\_\_\_\_\_  
In the Matter Of \_\_\_\_\_ )  
 )  
Sequoyah Fuels Corporation )  
and General Atomics )  
 )  
(Gore, Oklahoma Site Decontamination )  
and Decommissioning Funding) )  
\_\_\_\_\_ )

Docket No. 40-8027EA  
Source Materials  
License No. SUB-1010

**NATIVE AMERICANS FOR A CLEAN ENVIRONMENT'S  
MOTION FOR LEAVE TO FILE REPLY AFFIDAVIT**

REPLY AFFIDAVIT OF TIMOTHY P. BROWN

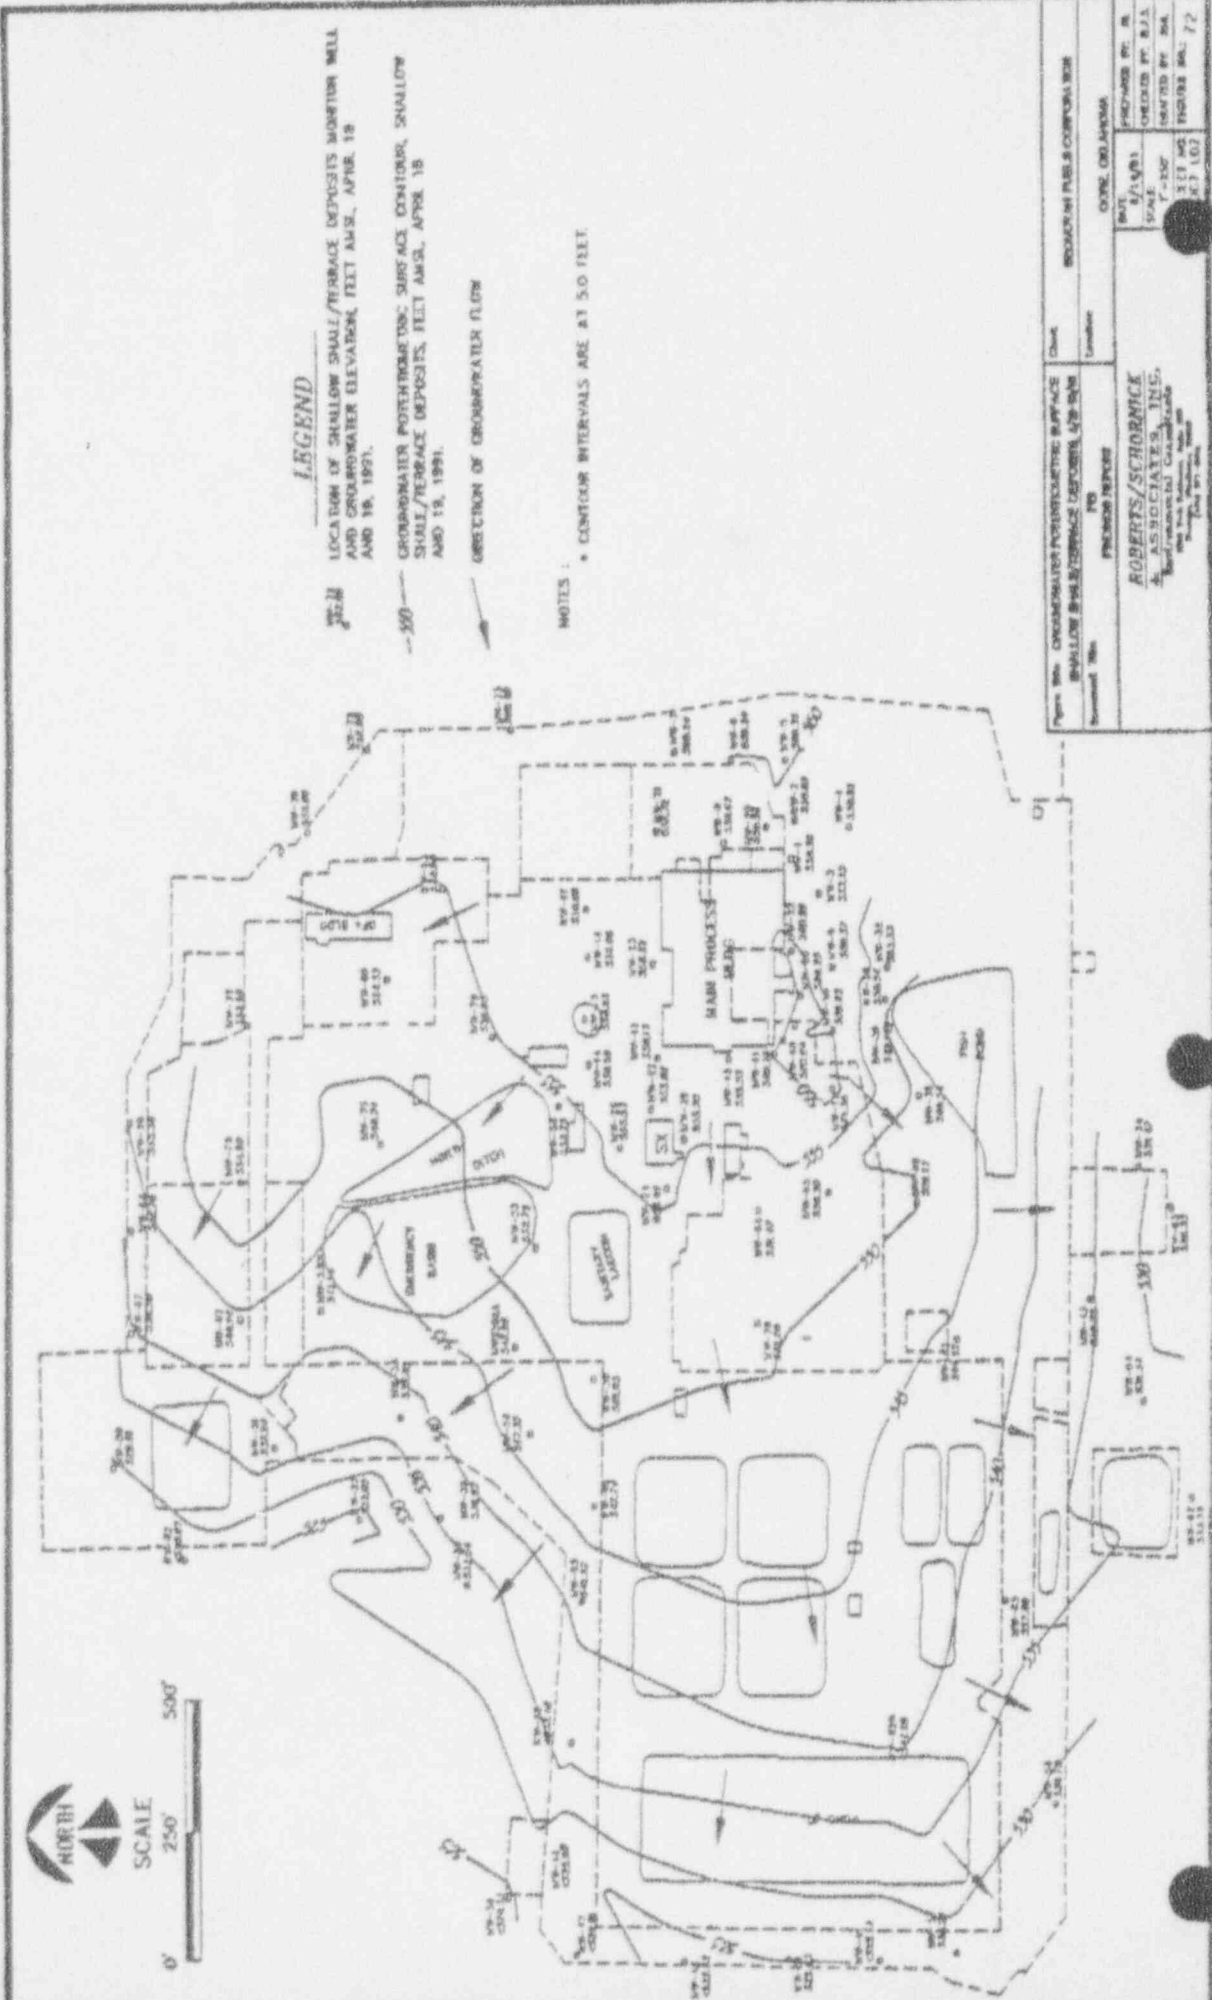
4) According to Mr. Smith, Attachments 3 and 4 of the Dietrich affidavit "show that the groundwater flow beneath the fertilizer pond area is generally westward and away from Mr. Henshaw's property." However, Attachments 3 and 4 do not support this assertion. First, they show groundwater flow in at least one other direction: in the southeast portion of the small area portrayed by these maps, flow is directed southerly. Second, as discussed in my previous affidavit at paragraph 7, these maps cover too small an area to reliably show groundwater flow in the entire area that potentially affects Mr. Henshaw's property. For instance, although the maps show groundwater flow in a southerly direction, it is impossible to tell what the flow field does south of the area. What little information is provided in Attachments 3 and 4 shows a rather complicated potentiometric surface. Thus, it is impossible to reliably predict where contaminants entering the groundwater will travel, based on this very small picture.

5) In paragraph 8 of his affidavit, Mr. Smith claims that groundwater flow in the processing area north of the fertilizer ponds "radiates westward, northwestward, and southwestward from the topographically high area occupied by the main process building." In making this statement, Mr. Smith effectively concedes that he oversimplified when he stated in the preceding paragraph that groundwater flow in the area is "generally westward." In truth, as Mr. Smith acknowledges, groundwater flow radiates from the process area in an arc of at least 180 degrees. Moreover, other maps prepared for SFC by Mr. Smith's company, but not cited by him here, show that the radial flow is even broader than he describes, and includes southerly flow. See Figures 72 and 73 of the FEI (Attachments 1 and 2). Finally, as stated by Mr. Smith, the main processing building is in a "topographically high area", (Smith Affidavit, paragraph 8). It is common for such topographic highs to radiate flow in all directions. Thus, none of the information cited by Mr. Smith establishes that groundwater cannot flow toward Mr. Henshaw's property from the process area; and indeed SFC's own data indicates that groundwater flows in a southerly direction.

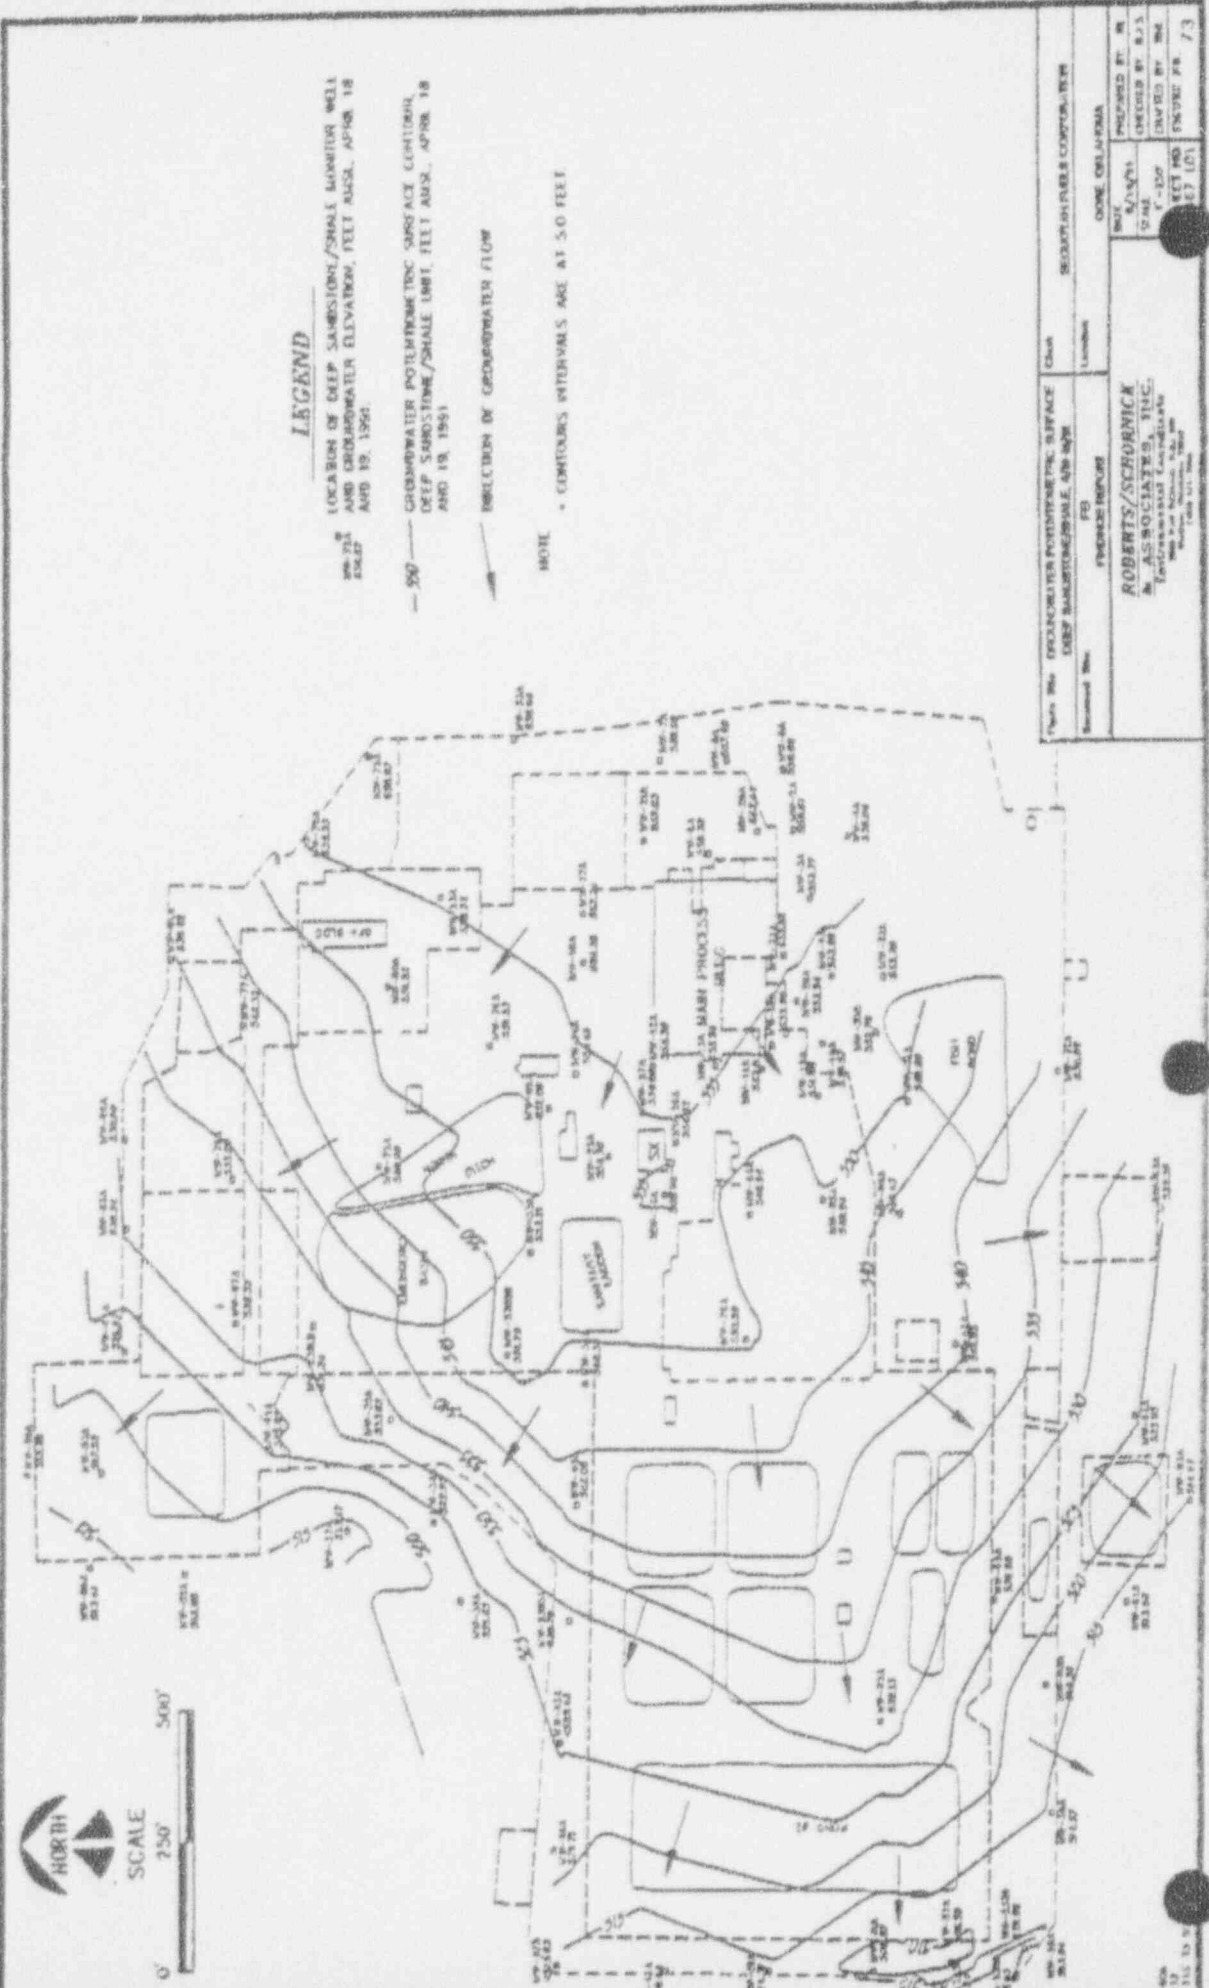
9) In my previous affidavit, I stated that Mr. Dietrich's affidavit failed to address the possibility that deeper levels of groundwater may flow toward Mr. Henshaw's property; and that none of SFC's reports provide any data for depths greater than 40-50 feet (paragraph 7(d)). Mr. Smith asserts in response that "The FEI and Addendum investigations showed that most of the contamination at the site was in the upper groundwater horizon (shallow shale/terrace) and generally lower levels of contamination occurred in the deeper sandstone/shale groundwater horizon (Attachments A-6 and A-7)." Accordingly, he states that "this information was sufficient to convince the investigators that the possibility of significant contamination in even lower zones was

unlikely and investigation to deeper zones was unnecessary", (Smith Affidavit paragraph 13). However, Mr. Smith's assertions are directly contradicted by SFC's own documents. First, contrary to Mr. Smith's statement, Figure 78 (Smith Attachment A-7), of the FEI shows high levels of uranium (i.e., greater than 10,000 ug/l) in the deep sandstone/shale unit, including a plume in the northwest area of the site which does not appear in the plume map for the hydrologic unit above (Figure 77, Smith Attachment A-6). Moreover, it can be seen from Mr. Smith's Attachments A-2 and A-4 that soil uranium concentrations diminish with depth. Yet, very high contaminant levels are seen in the upper bedrock immediately below the soil. If the investigators had assumed no contamination below the soil horizon, based on this apparent trend, then they would never have measured the contamination which exists in the bedrock. But there is also evidence that contamination with the bedrock does not diminish with depth. For example, examination of Table 29 of the FEI (Attachment 3) shows lithological boring analyses which do not support the conclusion that contamination diminishes with depth. Hole BH-12A shows constant high levels of nitrate and uranium down to 32 ft. BH-26A shows high nitrate and uranium levels to 35 ft with uranium values increasing with depth. Boring BH-43A indicates that the highest nitrate values were found at the bottom near 38 ft. BH-71A shows its second highest fluoride and nitrate analysis at the base near 28 ft. BH-76A has its highest nitrate level at its base near 44 ft. BH-81A has this same feature as does BH-82A and 83A, which reaches 52 ft. depth. More such data could be cited. In short, data from the FEI does not support the contention that contamination has not reached deeper levels than SFC has examined.
